Client
Alistair & Paula Flutter

Project
11 View Road, N6 4DJ

Drawing Title
North-East Side Elevation Proposed

Project Number	Drawing Number	Revision
20055	PL-00-312	A

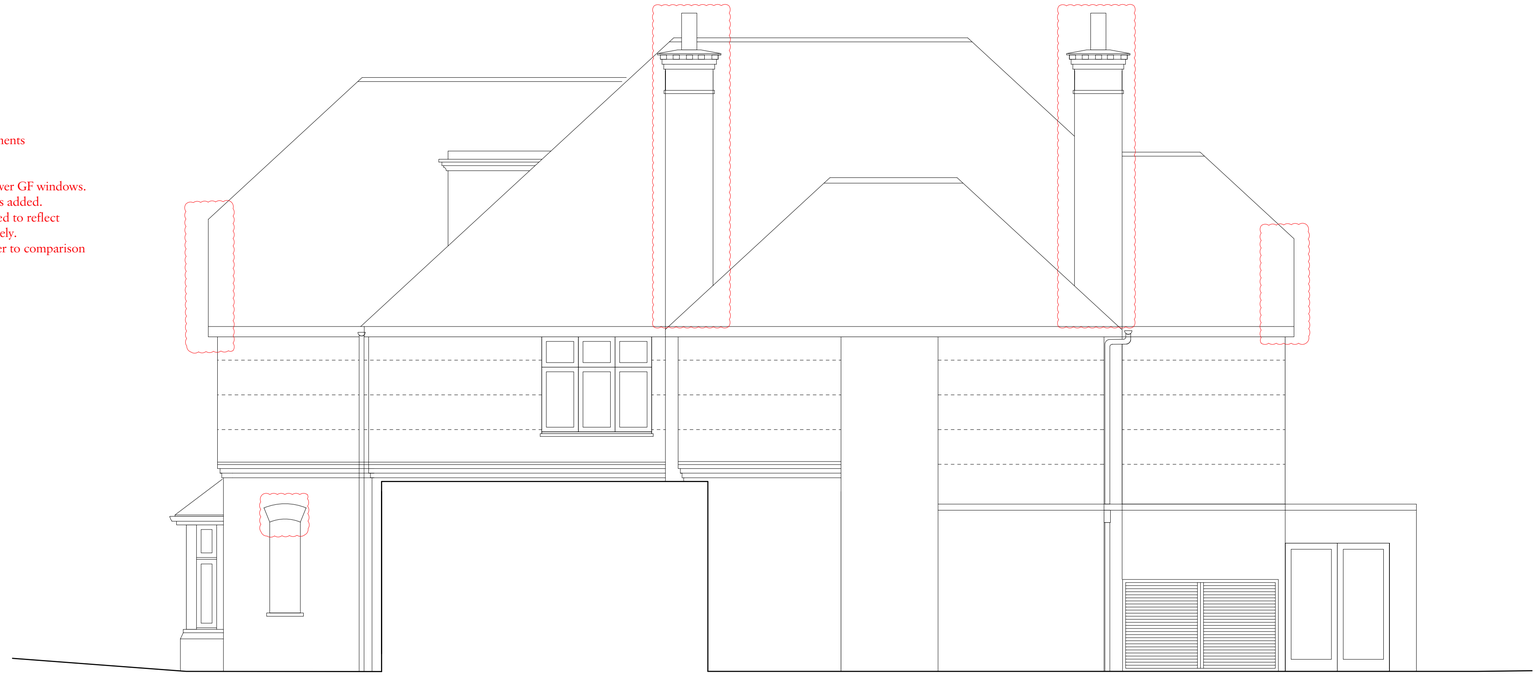
Rev A
Conservation Officer comments incorporated:

- Segmental arches added over GF windows.
- Bargeboards to gable eaves added.
- Chimney masonry amended to reflect existing detailing more closely.
- Tile banding clarified (refer to comparison drawings).
